Discovery Point Masterplan  
Wolli Creek

**Internal Memorandum****PDR-INTM-000002**

**To:** Mr Christopher Pope - Australand  
**Cc (2):** Mr Matthew Allen - Bates Smart Pty Ltd (*1 more...*)  
**From:** Mr Con Vink - Paul Davis Rajalingam  
**Sent:** Thursday, 25 March 2010 2:44:35 PM EST (GMT +11:00)  
**Status:** N/A  
**Subject:** **Stormwater Drainage, Flooding and Groundwater Levels**

Scale	1 : 500	@ A1	Checked
Drawn	AW		MA
Project no.	S11191		
Status	PRELIMINARY		
Plot Date	24/03/2010 6:31:22 PM		
Plot File	C:\temp\masterplan-discovery-100129_Central_Matthew_S1118.mxd		
Drawing no.	DA2-100		Revision
	2

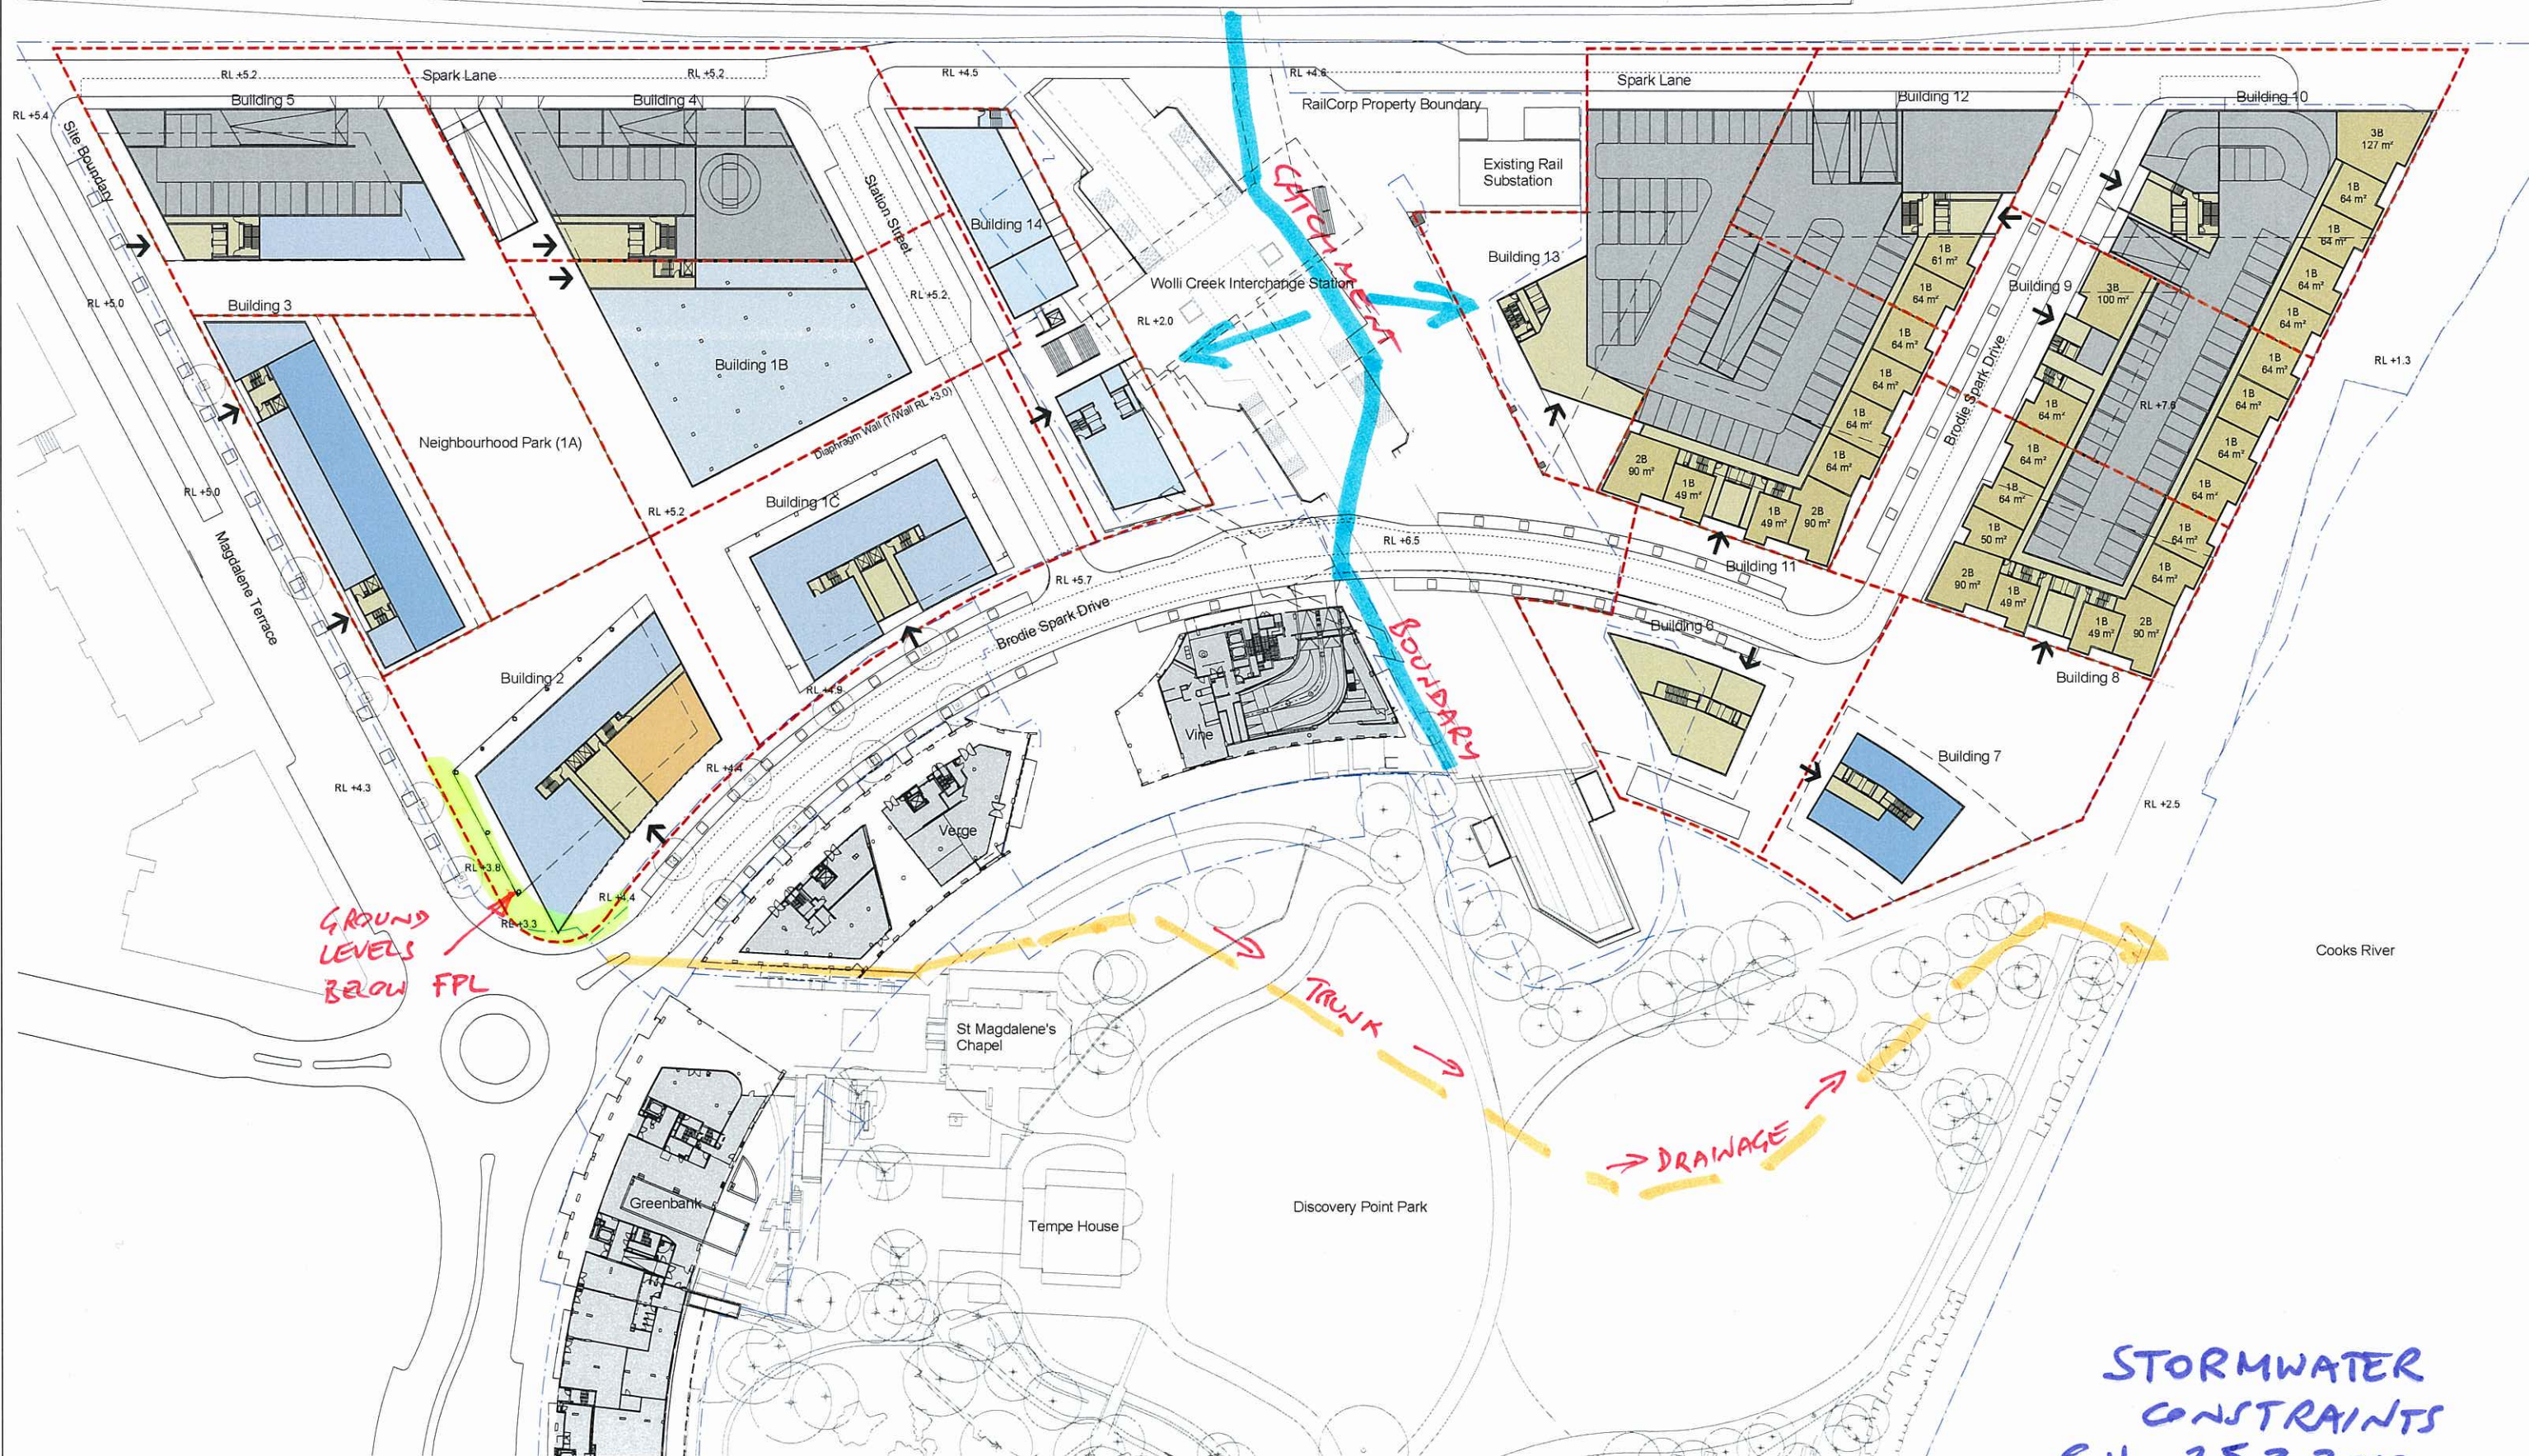
All of the remainder of the site is above RL 4.3 with the exception of a section of frontage to Site 3 at the intersection of Brodie Spark Drive and Magdalene Terrace. This extent has been highlighted in yellow on the attached plan.

The attached architectural drawing DA2-100 has been marked up to show the following:

1. Trunk drainage pipeline that serves stages 1 to 4, highlighted in orange, discharging to Cooks River. This pipeline was designed for 100-year Return Period.
2. Assumed catchment boundary is highlighted in blue. Land to the south of that line has been assumed to drain into the trunk drainage pipeline. The boundary may change with the new master plan, but the total area should not increase.

STORMWATER  
CONSTRAINTS  
C.V. 25.3.2010
